## CARRIER, PERSONNEL, FULL TRACKED, FV432 MK 2 AND 2/1

### GENERAL INSTRUCTIONS AND INDEX

Fig 1 - Driver's harness mounting detail

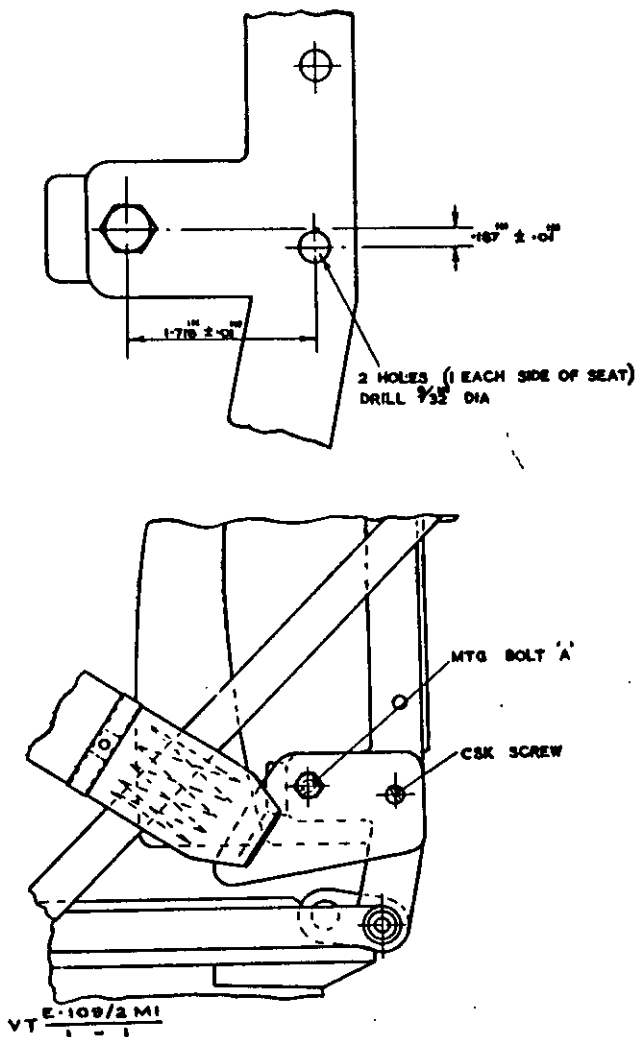
5. (a) Remove the driver's seat and runner assembly.
- (b) See Fig 1. Remove seat back frame bolts (A), retaining the nuts and washers. Mark off and drill a 9/32 in. dia. hole in each side member of the back rest to the dimensions shown.
- (c) When driver's harness is available, secure harness plates to the seat frame, using 1/4 in. x 7/8 in. bolts, original nuts and washers for frame holes (A), and 1/4 in. x 5/8 in. countersunk screws with self locking nuts for the new mounting holes.

Fig 2 - Welding cleats to roof plate

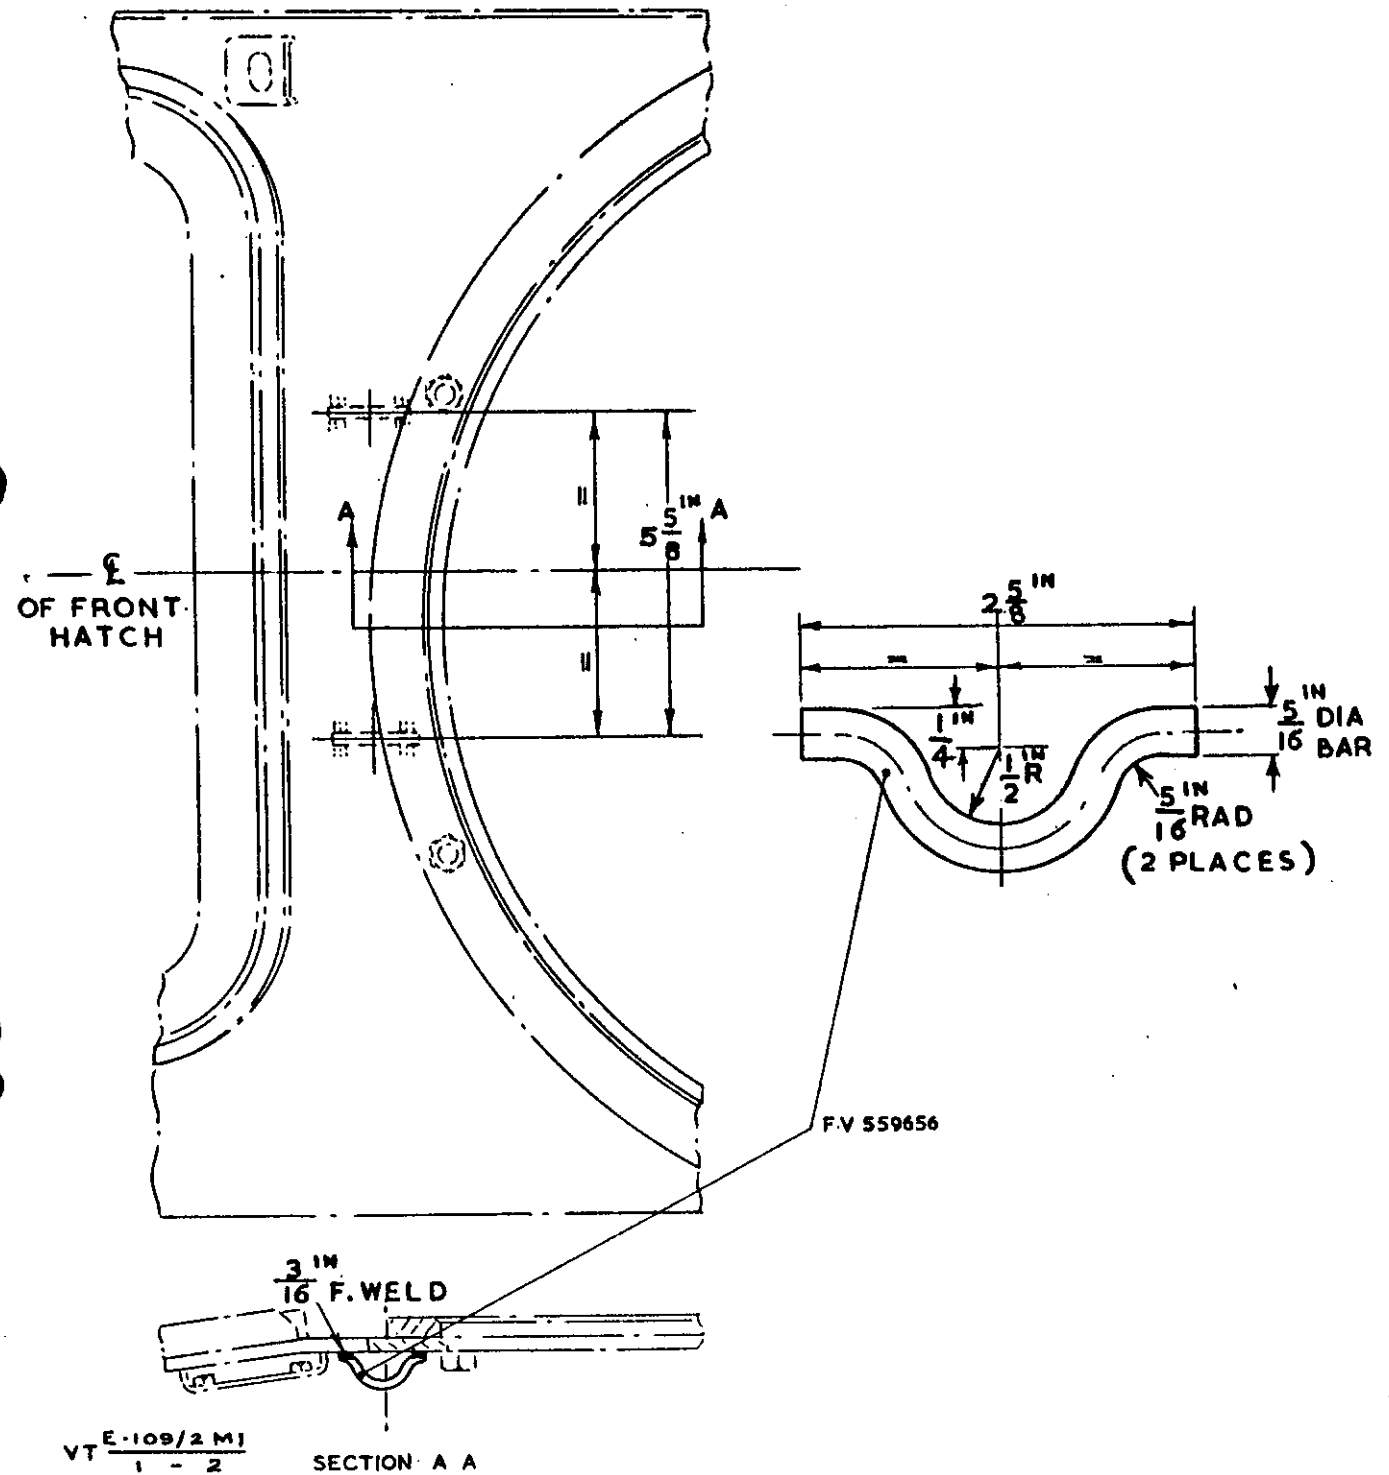
- (d) See Fig 2. Manufacture and weld two cleats to the front centre roof plate in the positions shown.
- (e) Refit driver's seat assembly.

Fig 1 - Stamping of filler caps

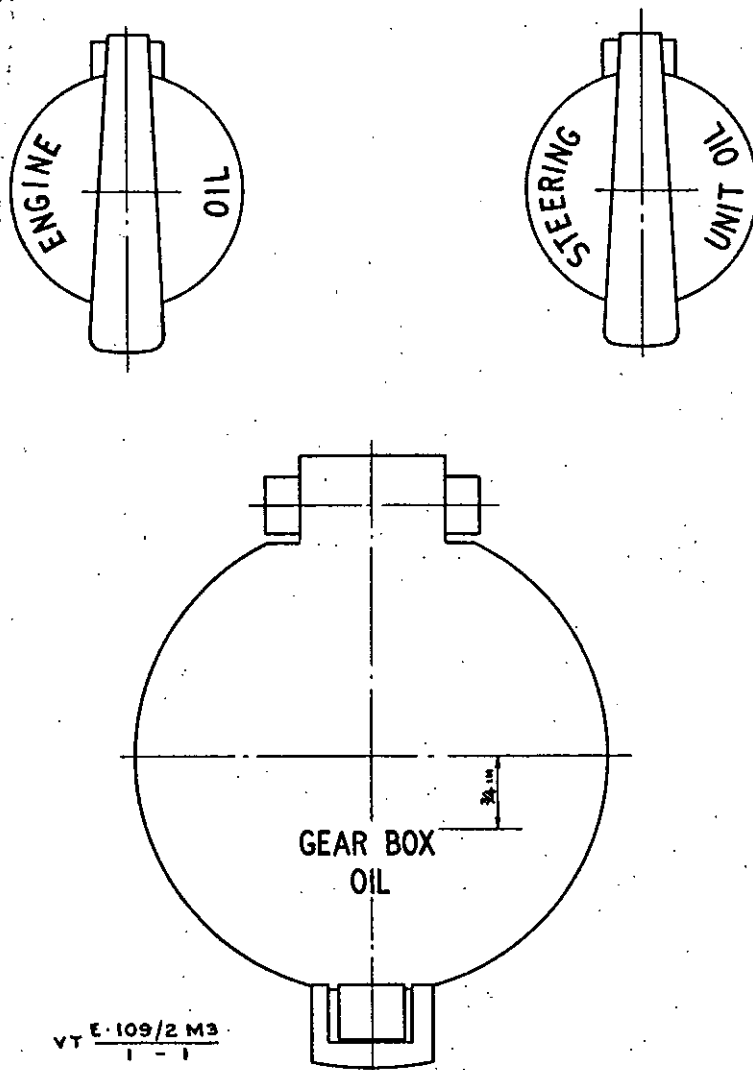
(d) Fill stamped lettering with black enamel paint, clean off surplus.

Fig 1 - Label fixing detail

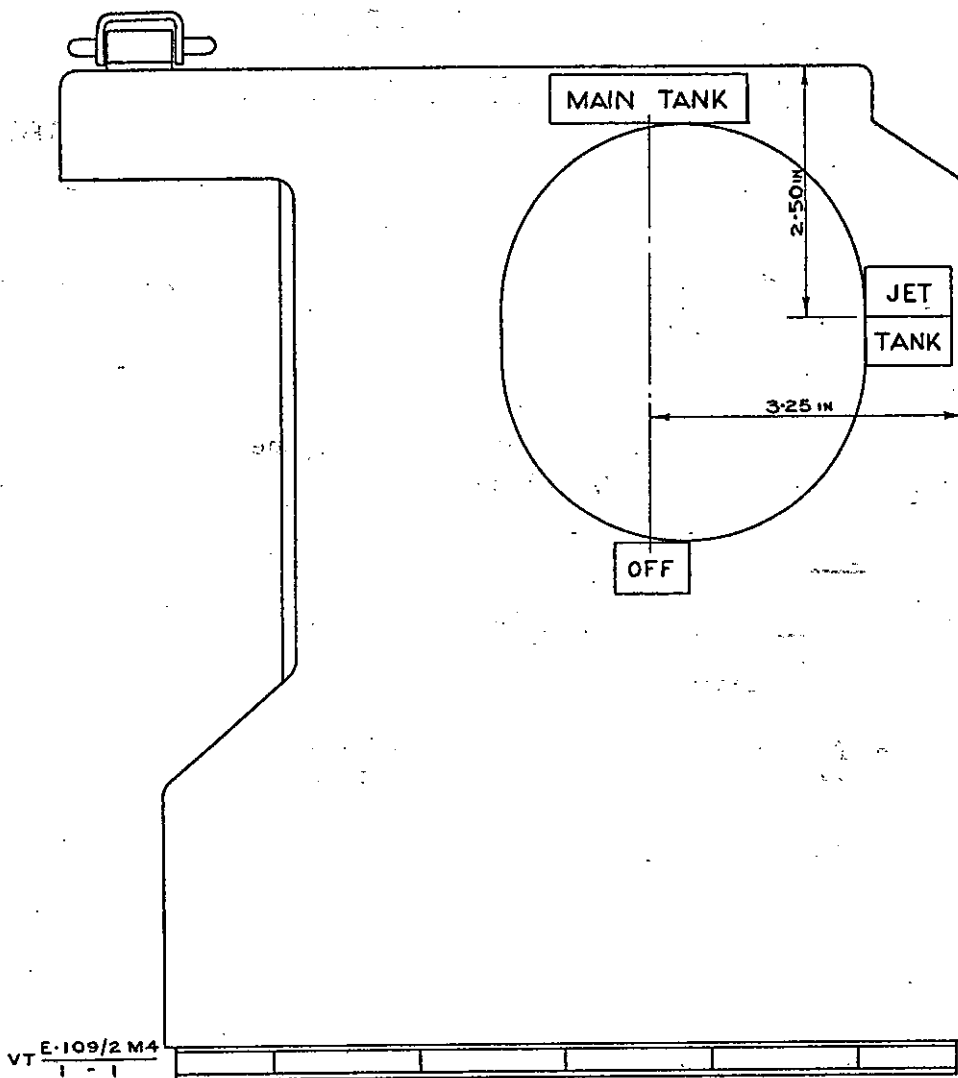
5. (a) Repaint fuel tap shield, blanking out existing black painted lettering.
- (b) See Fig 1. Secure plastic labels in positions shown by the adhesive backing.

Fig 1 - Oil trough detail

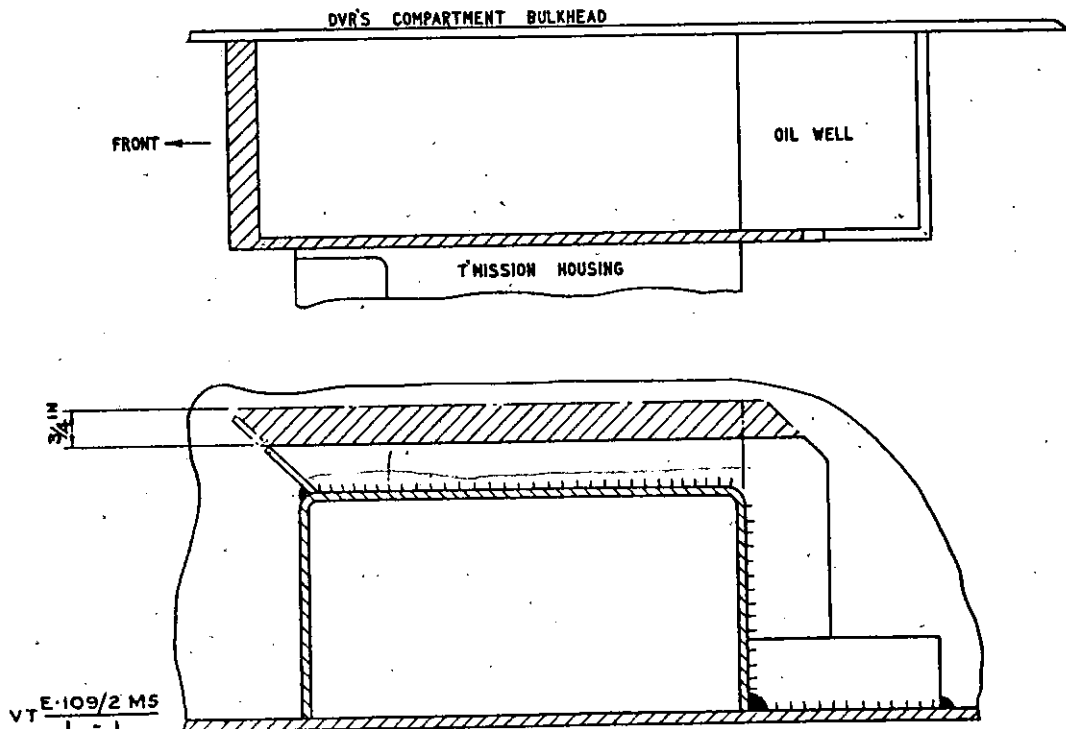
3. (a) Ensure power pack compartment is clean and free from fuel and oil.  
(b) See Fig 1. Mark off metal to be removed, to dimensions shown.  
(c) Remove metal by flame cutting or grinding.  
(d) Grind finish top edges and remove all burrs.

Fig 1 - Amended detail

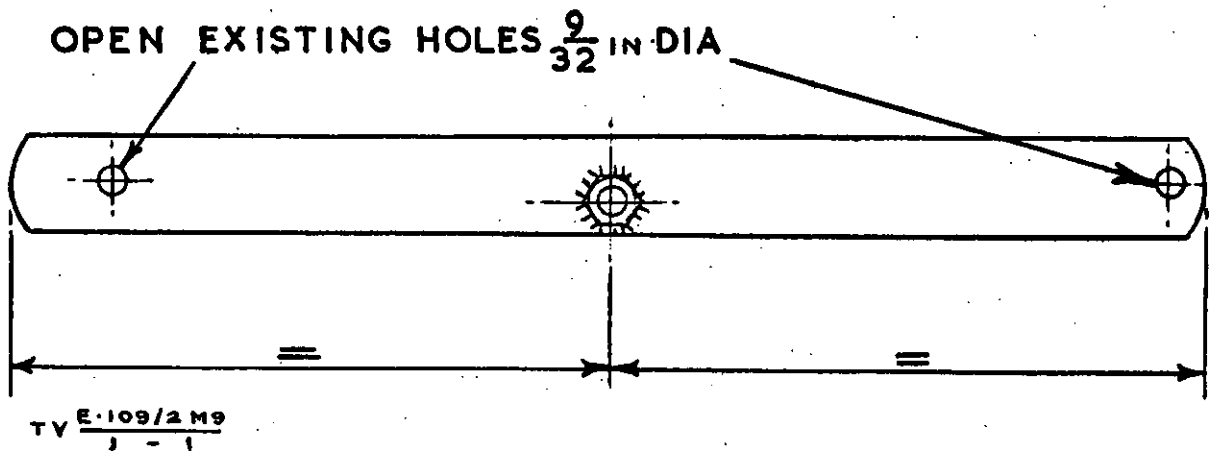
4. See Fig 1. Remove existing 5/16 in. UNF X 3/4 in. long stud and weld to support strip in the position shown. Open out existing 7/32 in. dia holes to 9/32 in. dia.

SUB-TITLE: Hydraulic tank breather

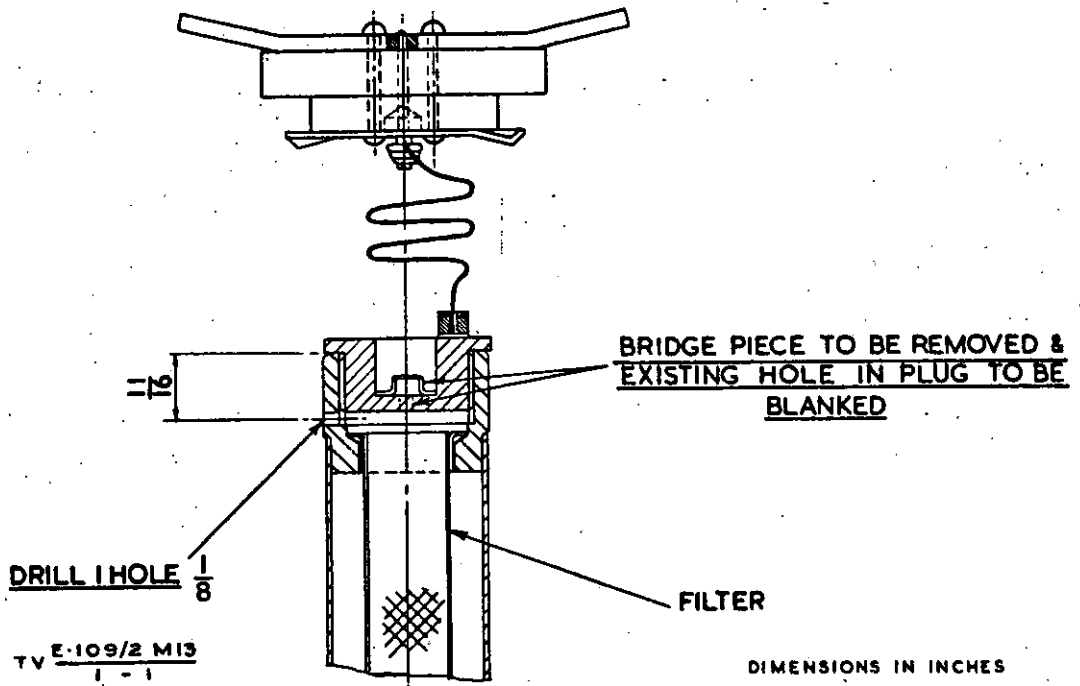
1. To prevent water collecting and entering the hydraulic oil tank via the screwed filler plug breather, a hole is to be drilled in the tube and the plug blanked off.
2. Item affected: Filler tube assembly (FV 586520)
3. Action required by:-
  - (a) Units authorized to carry out unit, field or base repairs:-  
When power pack is removed for repairs or overhaul, carry out this instruction.
  - (b) All recipients of this EMER:-  
Add particulars to Tkd Veh E 109/2 Misc Instr Index.

4. (a) Drain off about a quart of hydraulic oil and remove filler tube assembly. Remove screwed plug and gauze filter.
- (b) See Fig 1. Remove bridge piece and blank off existing breather hole using solder or 1/8 in. dia rod of suitable length. Drill 1/8 in. hole where shown.
- (c) Thoroughly clean tube with dry air blast to remove all traces of swarf.
- (d) Refit tube assembly and top up hydraulic tank to correct level.

Fig 1 - Strap - detail.

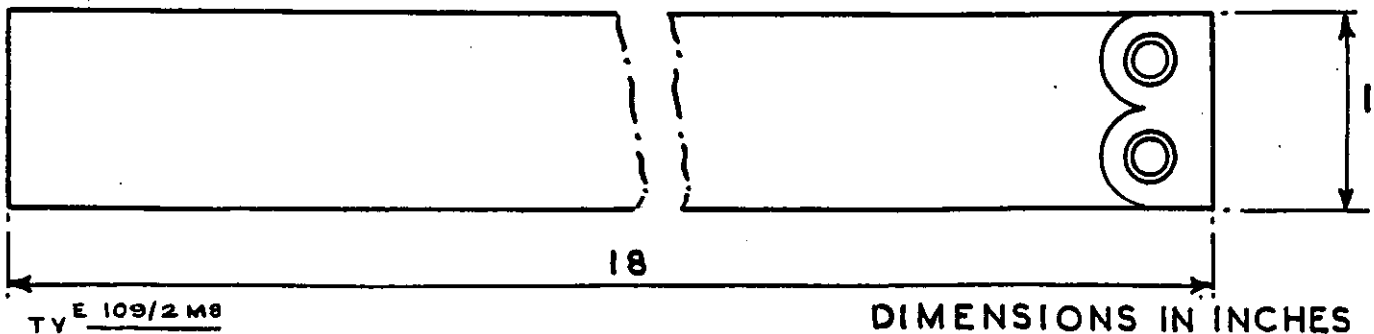
5. a. See Fig 1: Manufacture two straps to the dimensions given.
- b. Fit straps to existing stowage cleats on l.h. and r.h. fuel tanks, forming an end loop, and securing by rivets and washers.

Fig 13 - Stool

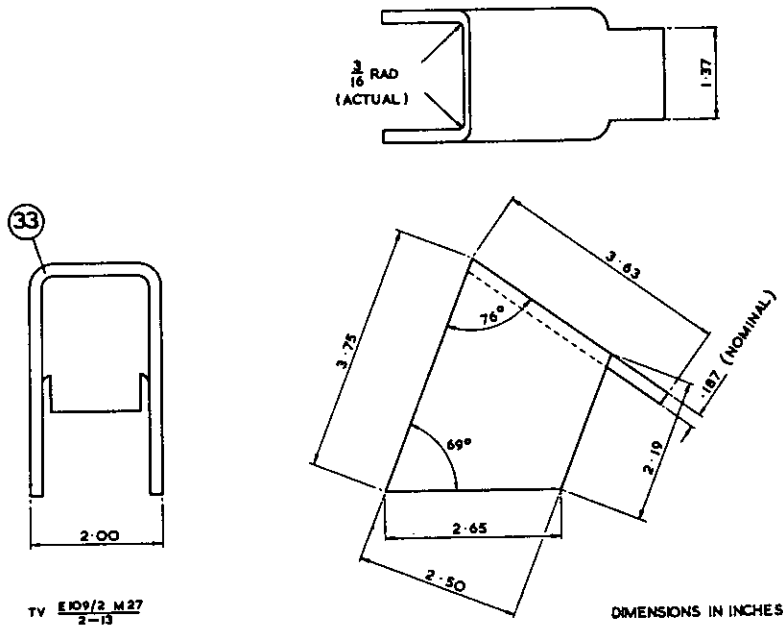
- d. Remove stool from door catch assembly, by cutting at the weld (original stool is replaced by new stool, see Fig 13.)
- Note: Handle must be reversed, see Fig 1.

Fig 1 - Strut - details

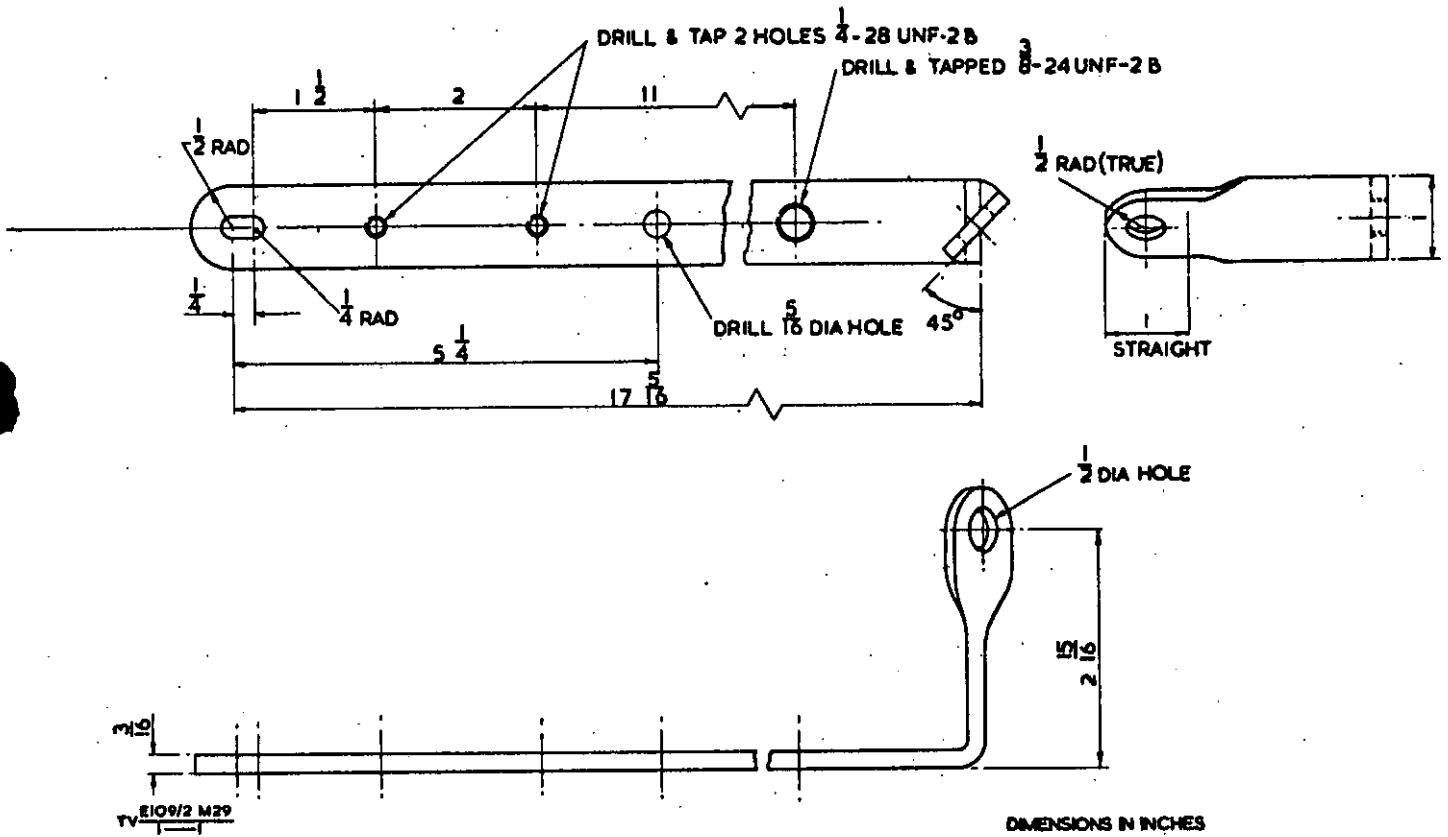
d. See Fig 2. Fit (to check) and stow the manufactured strut (FV 650062) to vehicle as shown, using the two 1/4 in. UNF screws and lock washers, listed in para 4 and retained 3/8 in. UNF screw, plain and lock washer as shown.

Fig 1 - Bracket modification detail

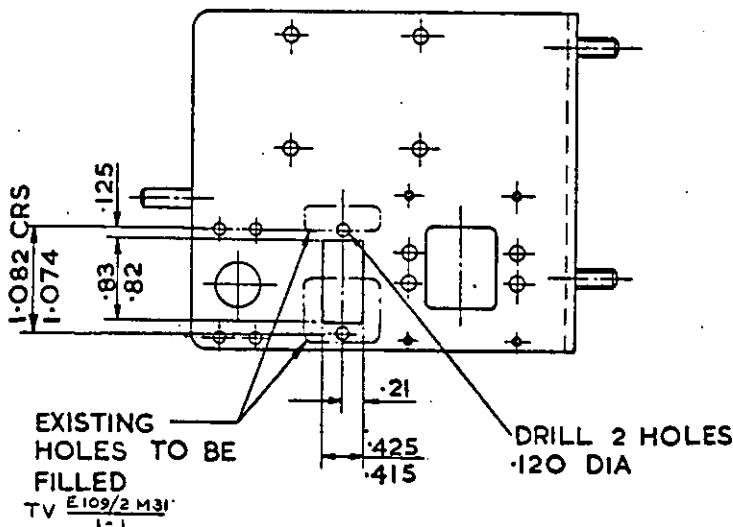
- To enable the alternative relay to be fitted (FV 394896/394906) modify the existing bracket (FV 530597) to the details shown in Fig 1.
- On re-assembly of bracket assembly (FV 530576) replace the cable length between terminals RB 23 and RB b with a wire link as shown in Fig 2.
- Cross off Mod No 2 from modification record plate on completion of modification.

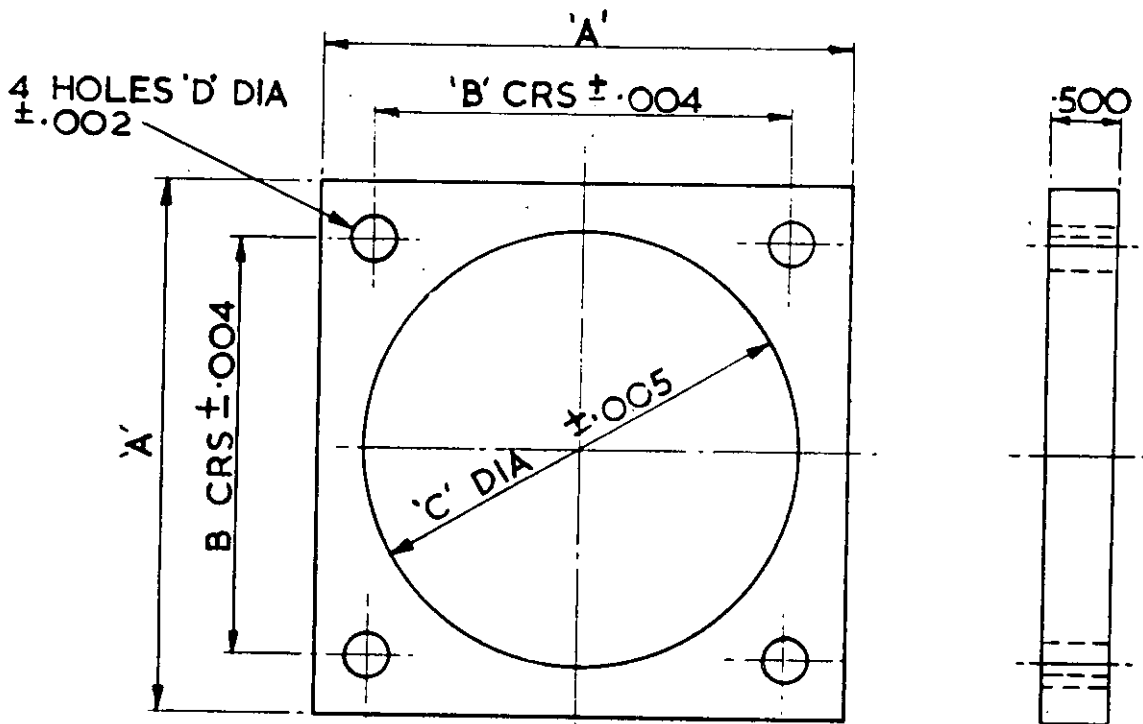
a. See Fig 1. Manufacture two distance pieces as per Dwg FV 635914 and one off each as per Dwgs FV 635915 and FV 635916. Plate all surface areas with cadmium/zinc.

Fig 1. Position of hole in pivot bolt boss  
(Dimensions in inches)

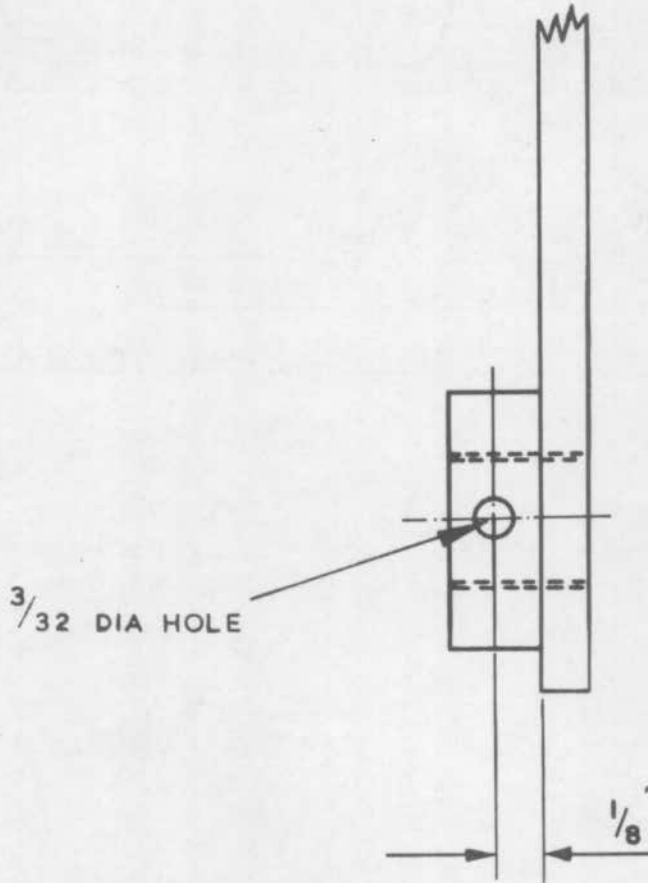
b. Drill a 3/32 in. dia hole through pivot bolt boss, as detailed in Fig 1 and fit spring pin detailed in para 4.
